PROPOSED FINGAL LANDFILL

Comments
on the
Hydrogeological Risk Assessment

EPA Oral Hearing

27th April 2009

DRILLHOLE NO: BRC4
SHEET: Sheet 1 of 2

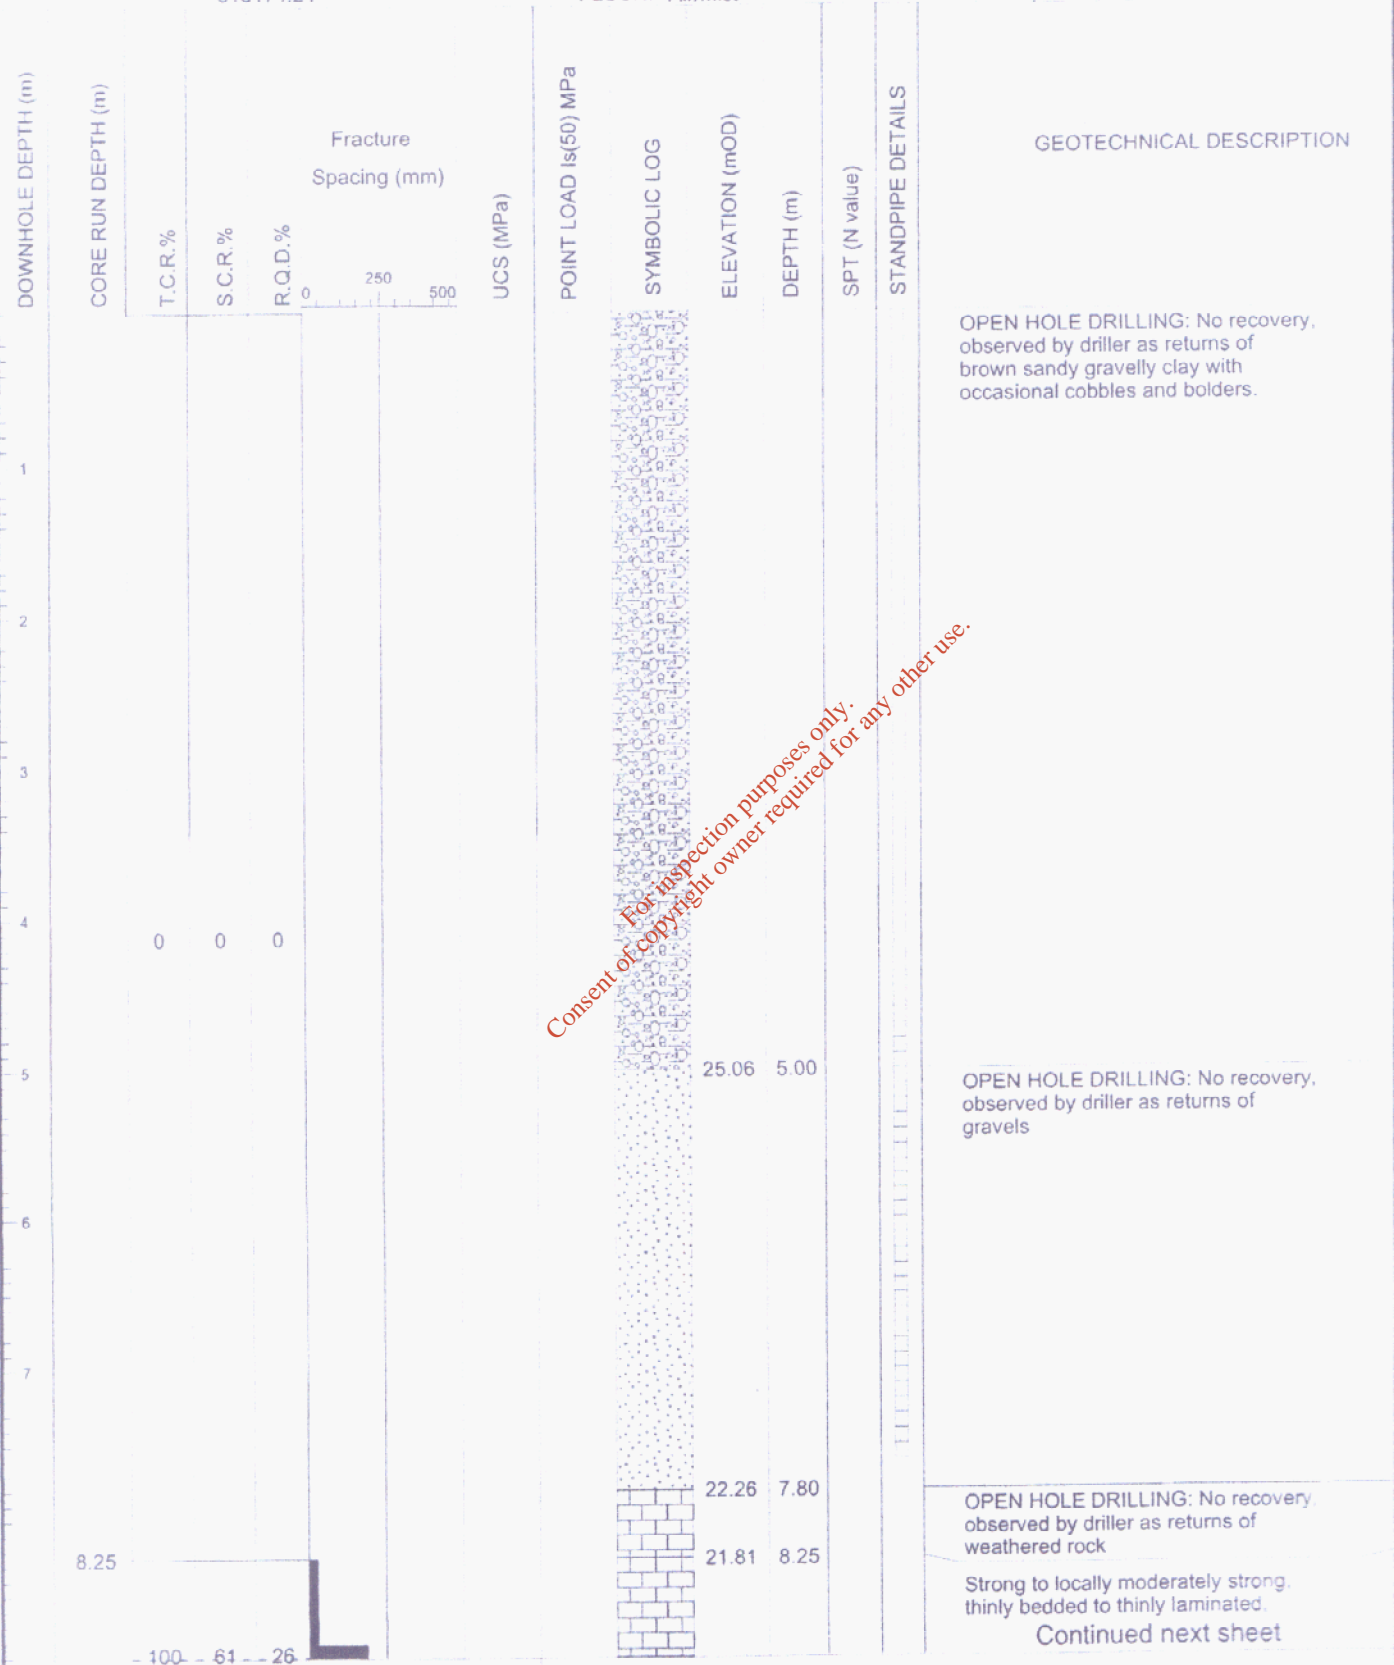
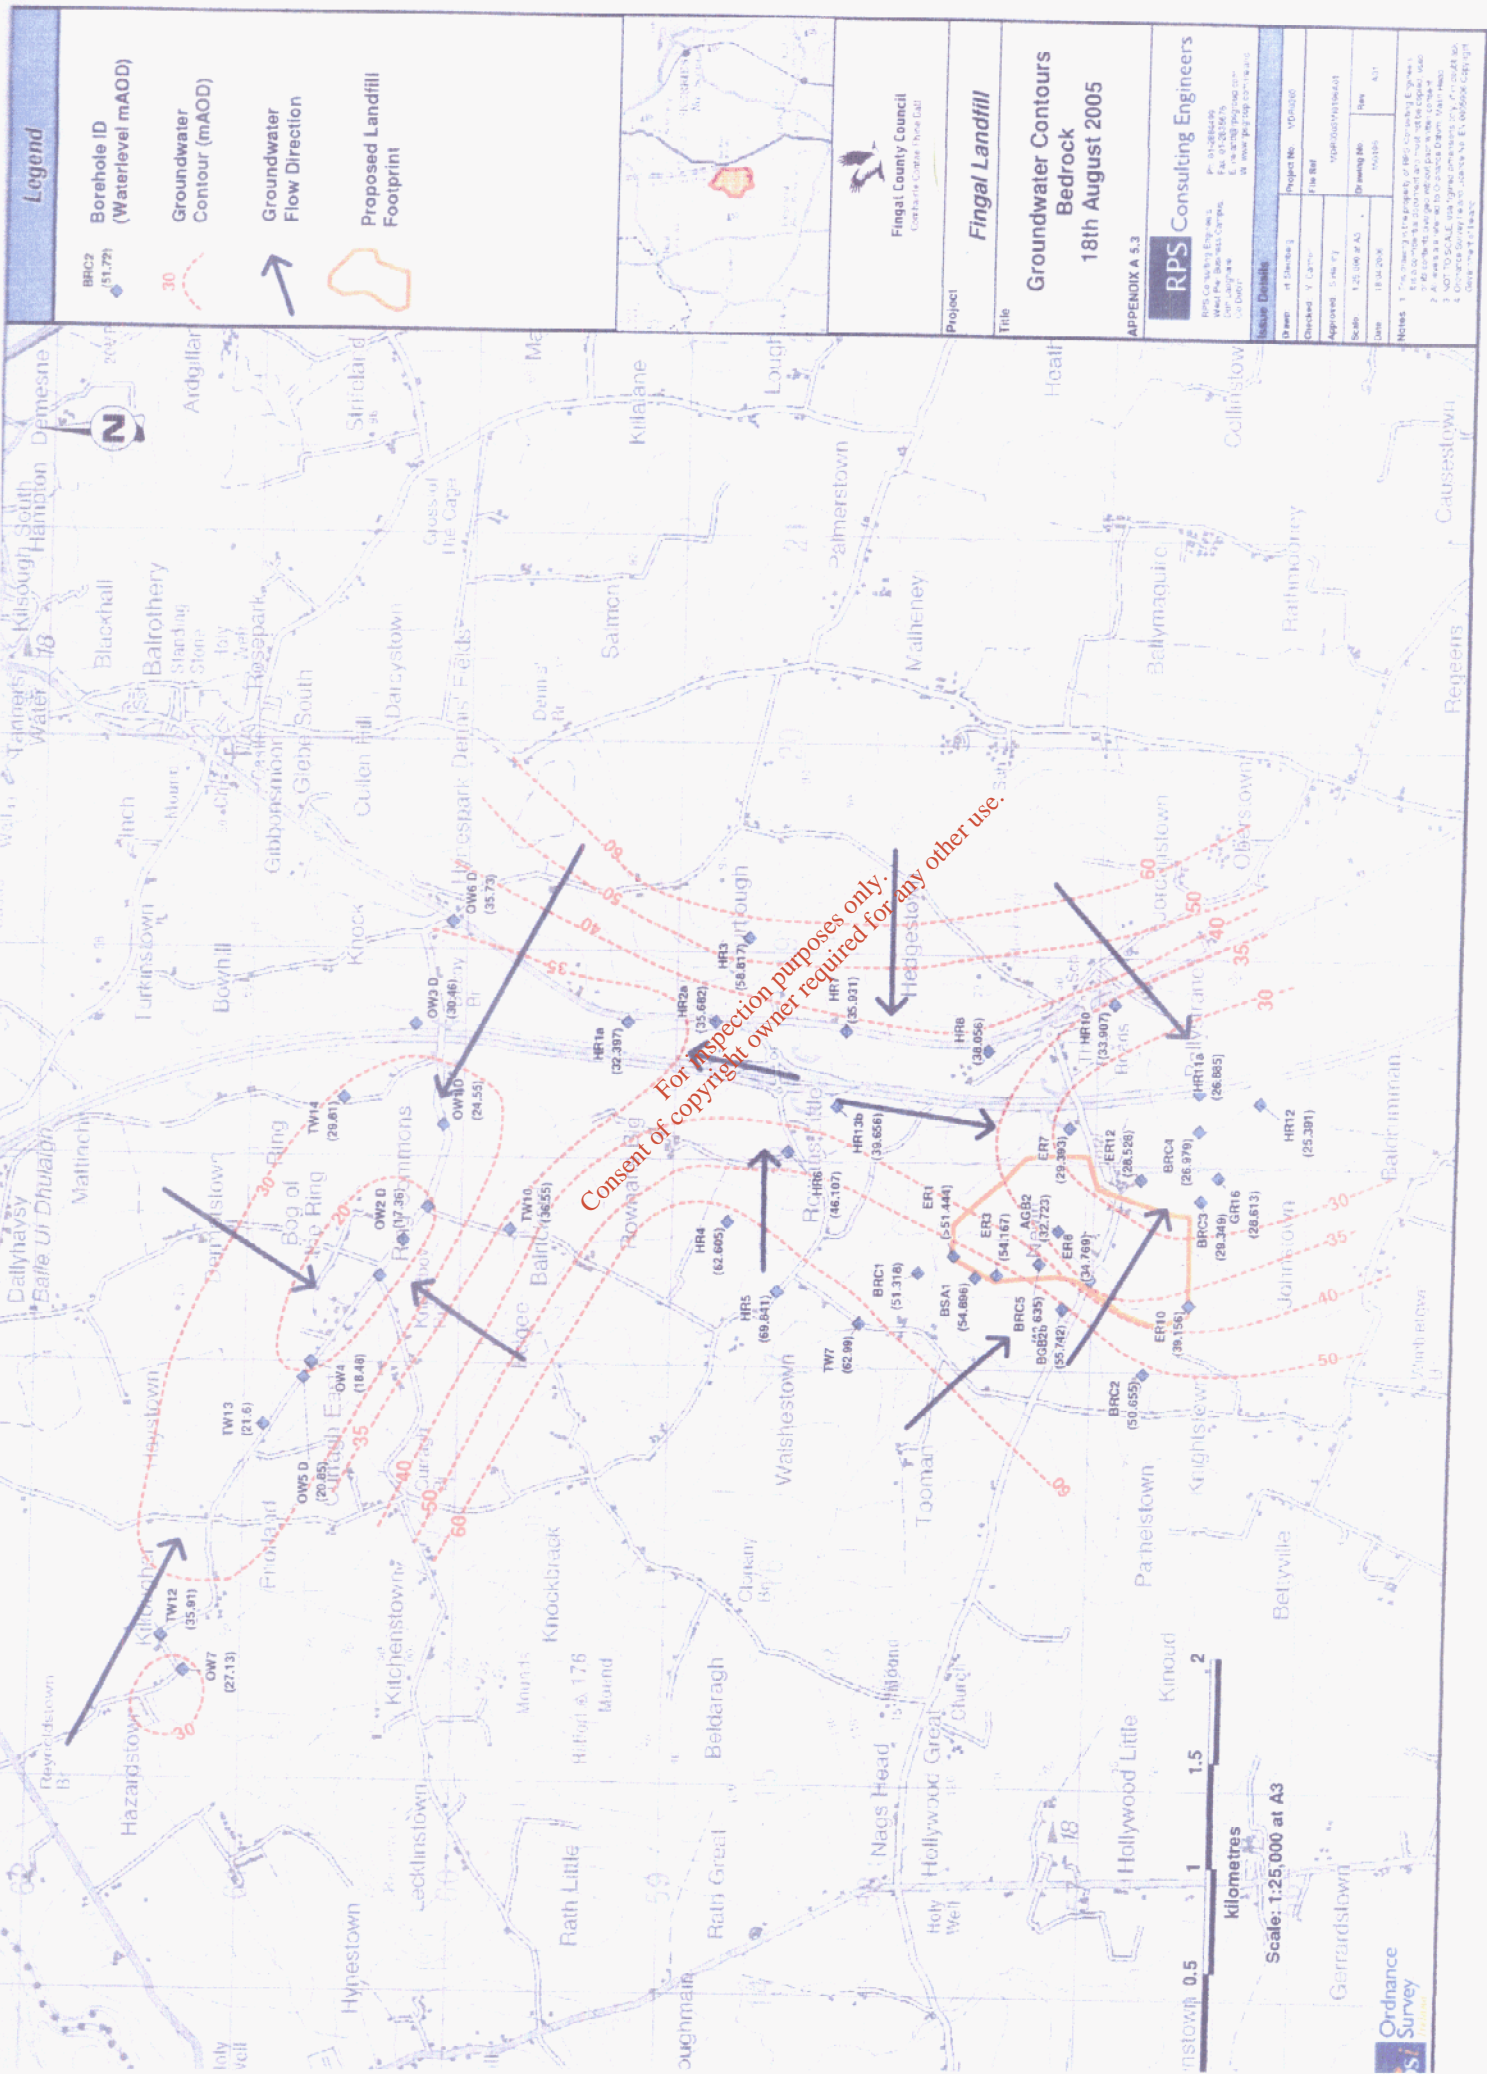
Borehole data (attached) shows a steep gradient in the clay water table across the site from west to east (see site map, section A-A'). The direction of flow along this section is assumed to follow the topographic contours (see detailed topographic map attached). The Geophysics map Depth to Bedrock along this section shows that the depth varies from ~8meters up-gradient of the site, to ~30 m below the site, to ~8 m down-gradient to the east.(see attached map). The down-gradient section is characterised by shallowing gravels – eventually 5m below ground level at BRC4- directly overlying bedrock. The HRA failed to note that 10

metres of clay is no longer present in this down-gradient area and that a geological barrier is absent.(see Gravel Map and BRC4 borehole data).
